Porsche Cars North America, Inc.  
Michael Scott, Director Regulatory Affairs  
One Porsche Drive  
Atlanta, GA 30354  
Telephone: 770-290-2726  
Email: michael.scott@porsche.us

**Comments to the Notice of Proposed Rulemaking for the Federal Motor Vehicle Safety Standards: Automatic Emergency Braking Systems for Light Vehicles.**

NHTSA-2023-0021

Figure 1 Last Point to Steer (LPTS) and Last Point to Brake (LPTB) general comparison (Continental AG)<sup>8</sup>

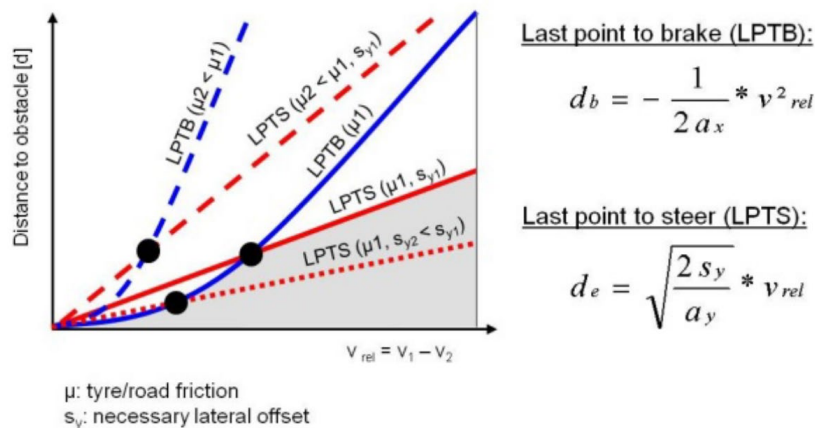
Braking distance increases with the square of the velocity. At high speeds, the last point to brake (in order to avoid a collision, "LPTB") lies far in advance of the obstacle. Given the sensory limitations, objects far ahead can be falsely classified, falsely located, or just not detected at all. Human drivers are also challenged by the limits of their perception and reaction time. This is why high-speed driving generally requires the highest possible level of attention.

However, human drivers have an advantage compared to AEB systems. They can base the decision of whether to brake or not on the availability of steering as an option to avoid the obstacle. As illustrated in Figure 1, the last point to steer ("LPTS") does not depend on the braking distance and therefore only increases linearly with speed. When closing in on an obstacle at high speeds, the driver can pass the LPTB with enough time to react and steer clear of the obstacle. As the AEB lacks the information of whether the driver is going to steer or not, it will assume the worst case and initiate emergency braking before the LPTB, far in advance of the obstacle, to avoid the collision through braking alone.

At high speeds, drivers usually find it more appropriate to steer their vehicle around obstacles. While planning this maneuver, system initiated emergency braking earlier than the driver would have otherwise chosen to steer would be perceived by the driver as a false activation. In alignment with NHTSA's commentary noted above, Porsche believes that

Porsche recommends that at higher speeds, AEB operation be focused on dynamic brake support (DBS) and AEB warning as defined in S5.1.1 and S5.2.1. For the lead vehicle, this would apply to speeds above 100 km/h and for pedestrian this would apply to speeds above 65 km/h. Crash imminent braking (CIB) would be required to operate above 10 km/h and up to the speeds listed above. Narrowing the definition of AEB above the recommended speeds would ensure that drivers continue to receive warnings and that drivers who initiate braking would continue to be supported by DBS, but that drivers who may otherwise decide on a steering response would not have their vehicle initiate a CIB operation prior to the driver's full opportunity to steer.

Proposed revisions to S5.1.2 and S5.2.2 could include the following language:

**S5.1.2:** "Automatic Emergency Braking. A vehicle is required to have an automatic emergency braking system, as defined in S4 of this section, that applies the service brakes automatically when a collision with a lead vehicle is imminent. The **Crash Imminent Braking** functionality of the automatic emergency brake system must operate when the vehicle is traveling at any forward speed greater than 10 km/h (6.2 mph) **and less than 100 km/h (62.1 mph)**. **Beyond 100 km/h, the AEB system provides warnings and dynamic brake support.**"

**S5.2.2:** "Automatic Emergency Braking. A vehicle is required to have an automatic emergency braking system, as defined in S4 of this section, that applies the service brakes automatically when a collision with a pedestrian is imminent. The **Crash Imminent Braking** functionality of the automatic emergency brake system must operate when the vehicle is traveling at any forward speed greater than 10 km/h (6.2 mph) **and less than 65 km/h (40.4 mph)**. **Beyond 65 km/h, the AEB system provides warnings and dynamic brake support.**"

Figure 2 Summary of lead-time, phase-in and early action credit proposal

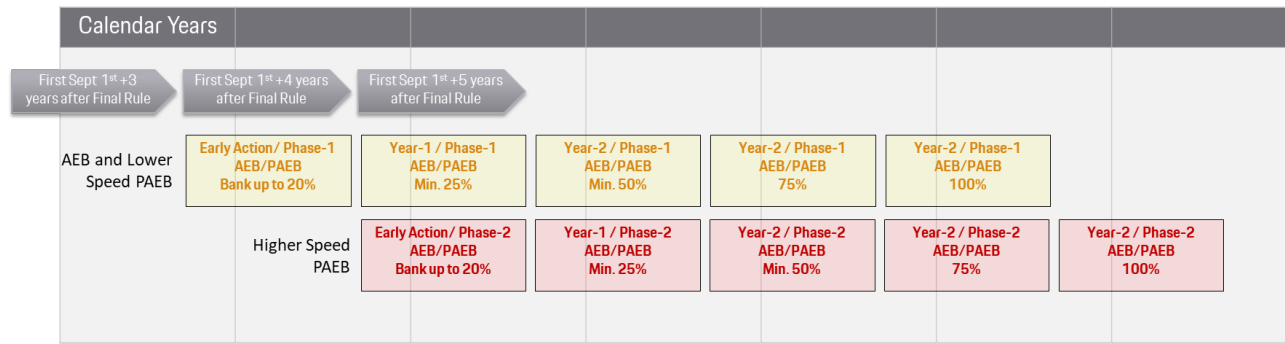
Given both the reengineering timing and architectural transition, Porsche projects that the NPRM's proposed three and four-year lead-time would not be sufficient for Porsche to achieve full compliance with the proposed requirements and would disrupt Porsche's planned product offerings. As such, Porsche proposes the following revised lead-time allowance, including the use of a phase-in, and early action compliance credits as outlined below. Further context regarding Porsche's proposal is provided in **Appendix-C** (Section Marked CONFIDENTIAL). While Porsche recognizes that NHTSA did not include percent-based phase-ins or the use of early action credits in the NPRM, Porsche believes that both of these mechanisms are within scope of the NPRM given that each of these mechanisms have extensive regulatory history and are commonly used by NHTSA and other Federal and State agencies in helping to manage compliance with new or updated regulations. The three elements are summarized in the following sections and in Table 1 and Figure 2 below.

Porsche proposes the following update to S5. In general, the recommendation would leverage three commonly employed regulatory mechanisms to help ensure that the full fleetwide compliance with the proposed AEB standards can be achievable.

- Providing an additional year of lead-time will be necessary for Porsche to complete the development and validation tasks for initial systems and vehicles to achieve compliance with the proposed standards.
- Porsche recommends compliance with the "Phase-1" requirements<sup>10</sup>, generally the requirements as described in S5.(a) with the exceptions outlined in S5.(b) and (c), to begin four calendar years following the publication of the Final Rule. This is one year later than proposed by NHTSA.
- Porsche recommends that "Phase-2" higher-speed PAEB requirements begin the following September 1<sup>st</sup> after Phase-1 or the first September 1<sup>st</sup> five years following publication of the Final Rule.

- Porsche recommends the use of a fleet phase-in for each manufacturer to help each manufacturer systematically upgrade the range of AEB systems and vehicle applications across their fleet. The phase-ins proposed would begin with the lead-time start dates above.
- Porsche recommends that compliance with the "Phase-1" requirements include the use of a four-year phase-in. The phase-in would begin with the lead-time as described above and would be a percentage of each manufacturer's fleet sold in the US. Suggested phase-in percentages are shown in Table 1 below. Porsche

recommends a phase-in of 25%, 50%, 75% and 100% beginning on the first September 1<sup>st</sup> four calendar years after the publication of the Final Rule. This linear phase-in is consistent with other prior rulemakings.

- Porsche recommends that compliance with the “Phase-2” requirements include the use of a four-year phase-in specific to the Phase-2 requirements. The phase-in would begin with the lead-time as described above and would be a percentage of each manufacturer’s fleet sold in the US. Phase-in percentage points are shown in Table 1 below. Porsche recommends a phase-in of 25%, 50%, 75% and 100% beginning on the first September 1<sup>st</sup> five calendar years after the publication of the Final Rule.
